Amendment C207 to the Hume Planning Scheme

Sunbury South Precinct Structure Plan

Expert Evidence Statement: Jason Black

Sunbury Hills - 725 Sunbury Road, Sunbury

Proposed Planning Controls – Land Not Served By Development Services Scheme – Potentially Developable Land

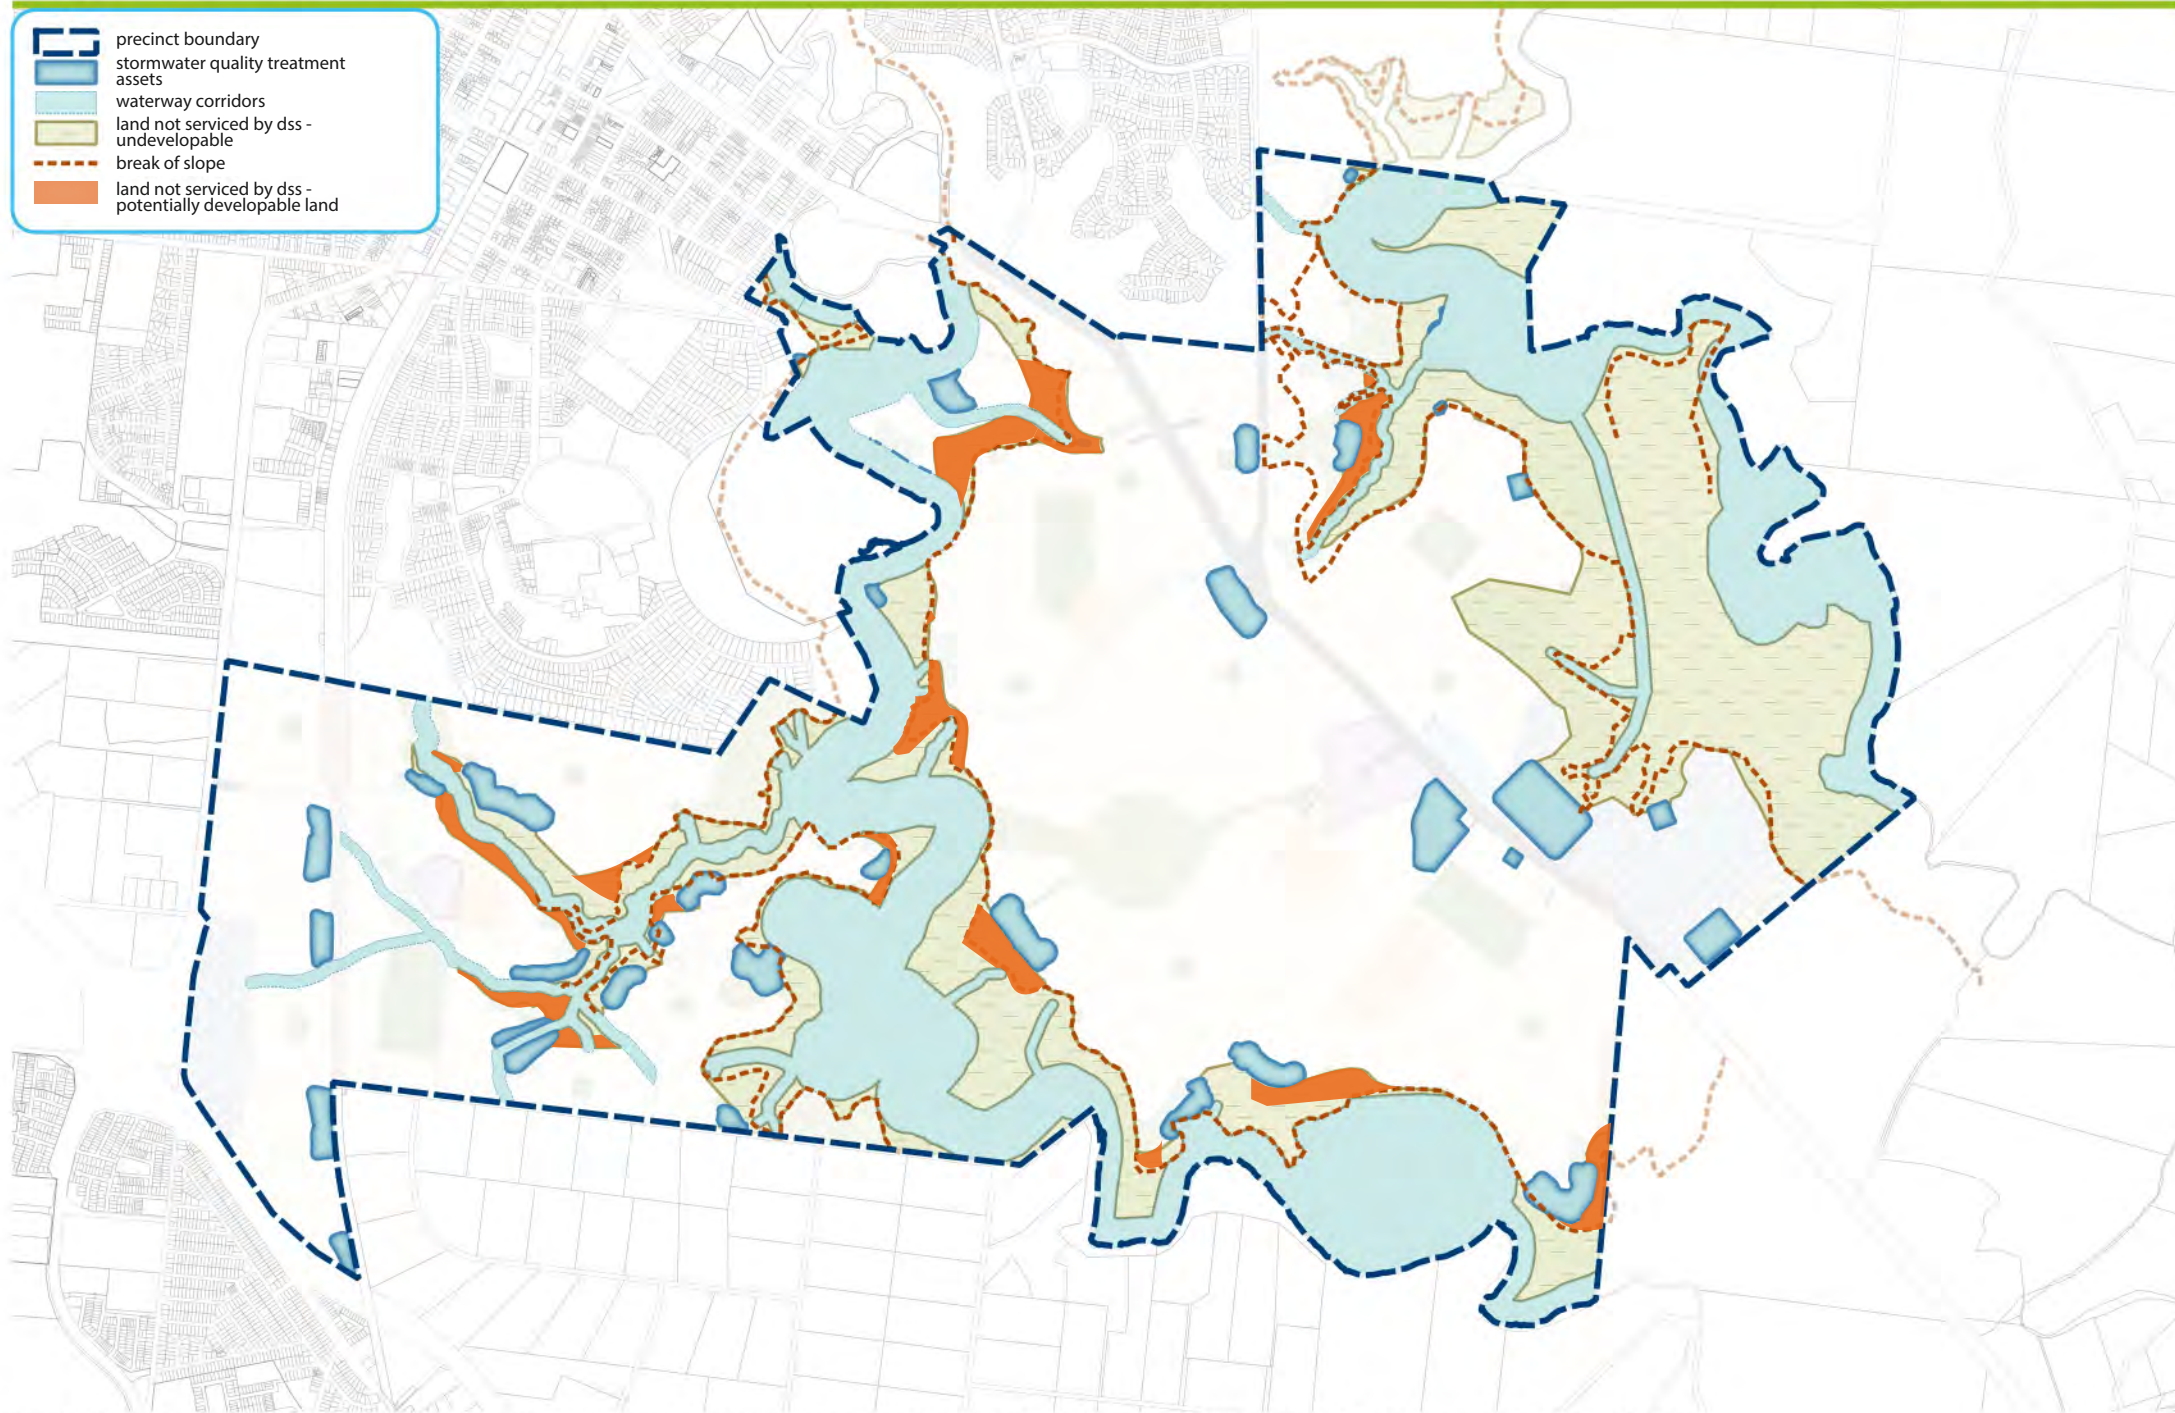
23. It is also noted that the recently proposed Plan - Potentially Developable Land (Appendix 2) also shows the eastern edge of the capability assessment area as having a break of slope. As noted above it is submitted that this area has a gradual slope and it is recommended that the Break of Slope shown along the eastern edge of this area be removed from the proposed Plan.
